From: Stanley, Curtis D. <CDStanley@trcsolutions.com>
Sent: Thursday, April 26, 2018 2:04 PM
To: Bratcher, Mike, EMNRD; Shelly Tucker
Cc: 'Camille J Bryant'; algroves@paalp.com; Weaver, Crystal, EMNRD; Rebecca Haskell
Subject: RE: Plains - Alpha Gathering Seg 3 Lat 6E (2RP-4147)

RE: Plains Marketing * 2RP-4147

Plains - Alpha Gathering Seg 3 Lat 6E

2RP-4147

DRAWING NAME: H:\Novall\Project Files\Plains\New Mexico\Concho Sreech Owl C1B1 Figure 2c Site Layout.dwg — PLOT DATE: May 14, 2018 - 10:18AM — LAYOUT: Layout1

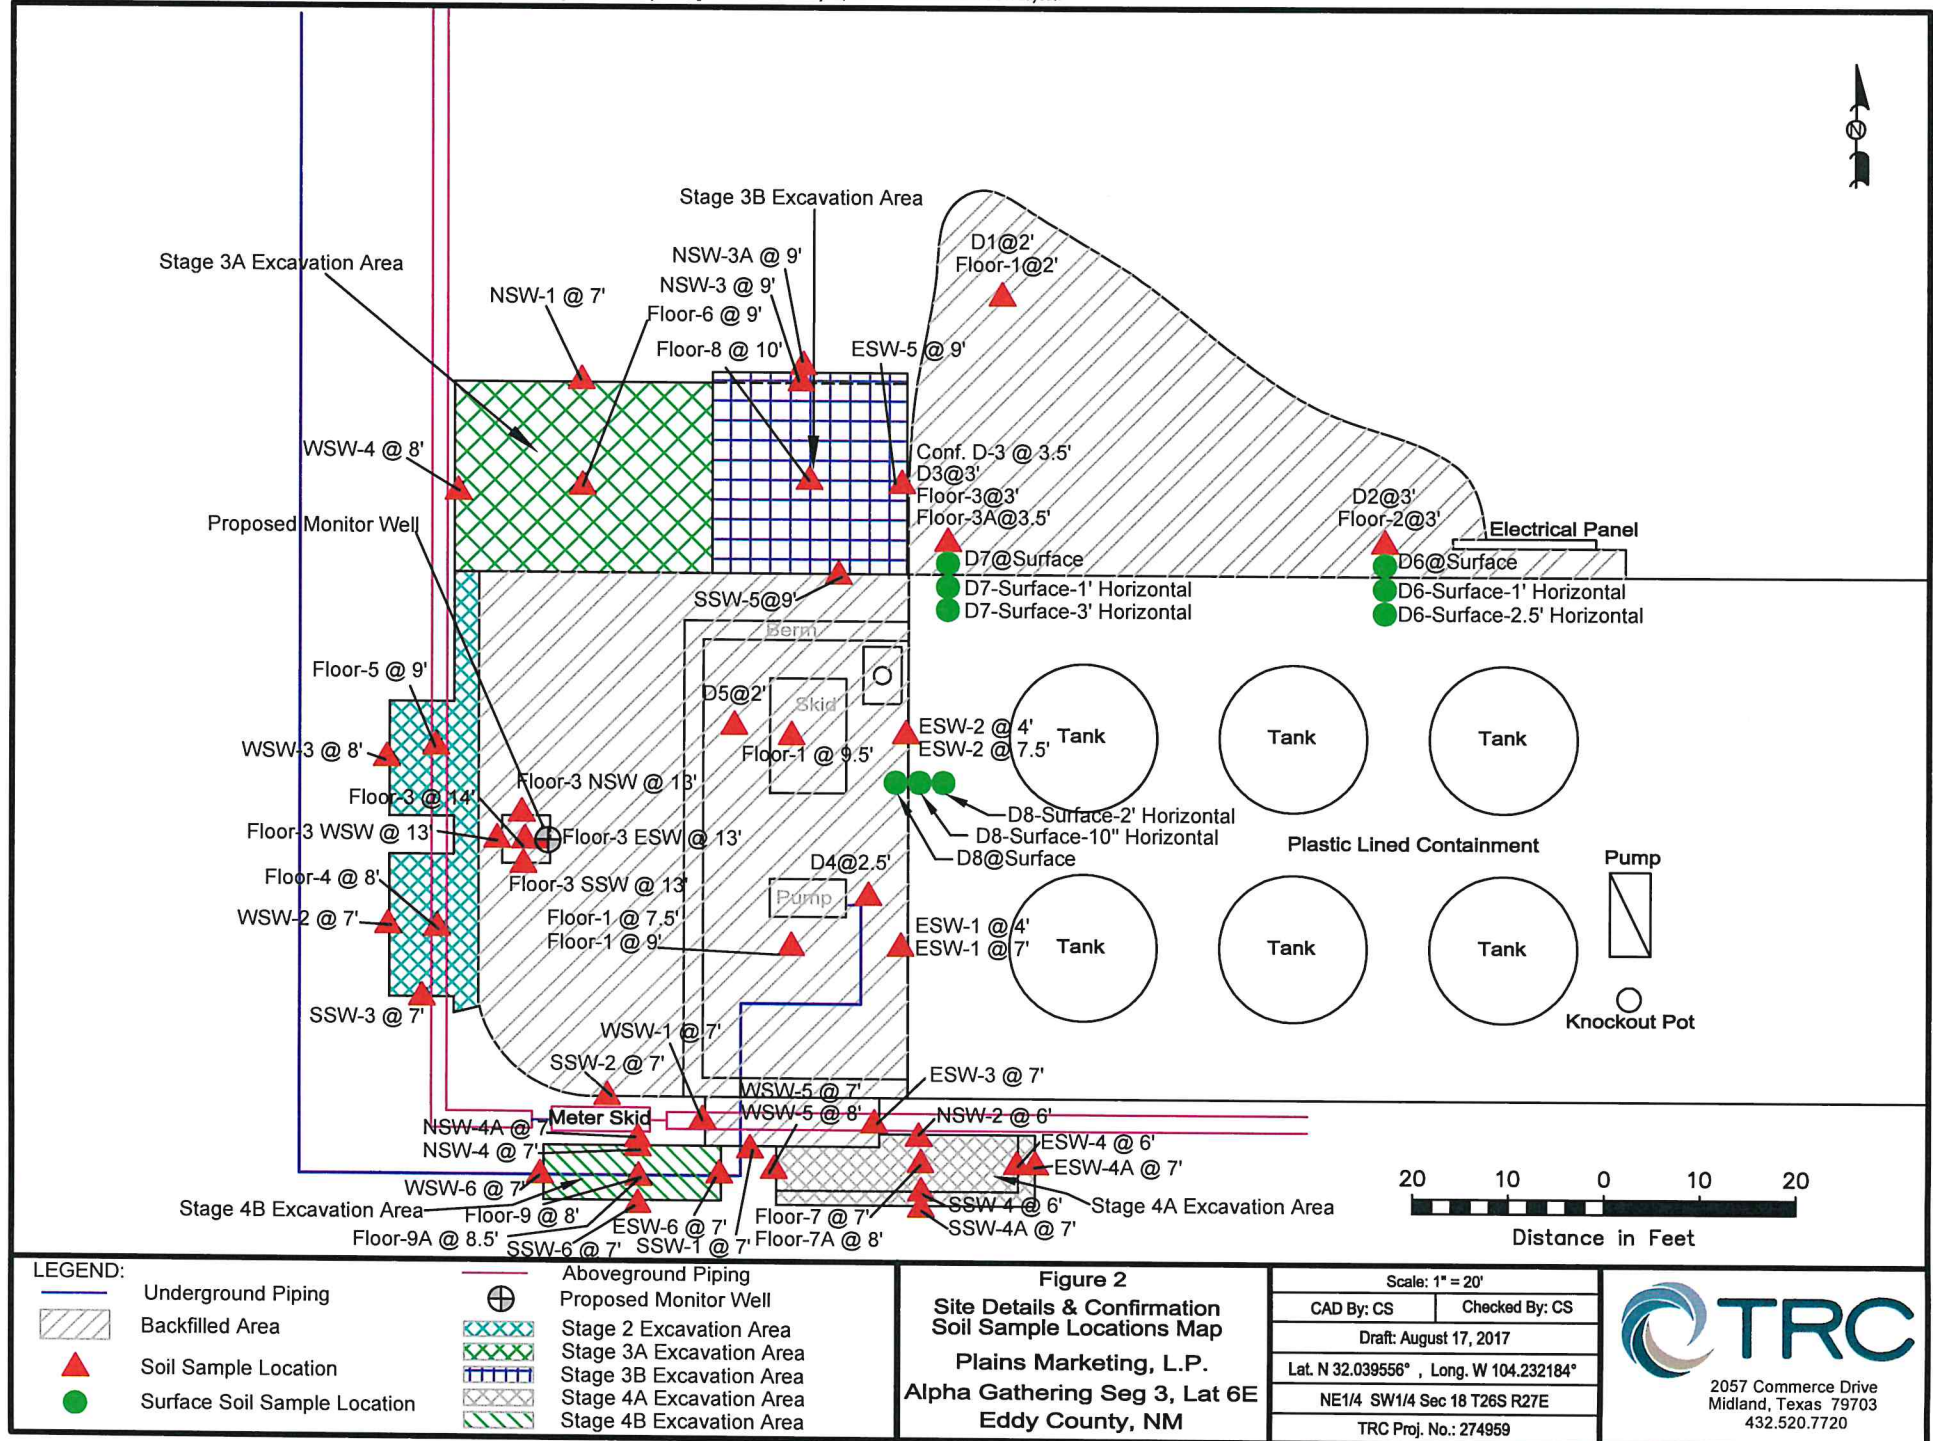
As Mike suggested, we are going to utilize a hydrovac to attempt to remove the elevated hydrocarbons represented by soil samples Floor-9 @ 8' and NSW-4 @ 7' in the Stage 4B Excavation area. We will be on site on Wednesday, May 2, 2018, a time has not been established as of now, but I will notify you as soon as we set a time.

It is our understanding we have permission to backfill the Stage 3B Excavation Area, Stage 4A Excavation area, and the area north of the Concho Screech Owl secondary containment with non-impacted, locally obtained like material. Is this correct?

You are approved to backfill as proposed. I don't remember if we talked about this or not, but in the 4B area, Floor 9 @ 8' and NSW 4 @ 7', is there any chance a hydrovac would be an option to get out some of the elevated hydrocarbons in those areas?

Thanks for the extra attempt in 4B. You are approved by OCD for backfill in the 3B, 4A and area north of the containment.
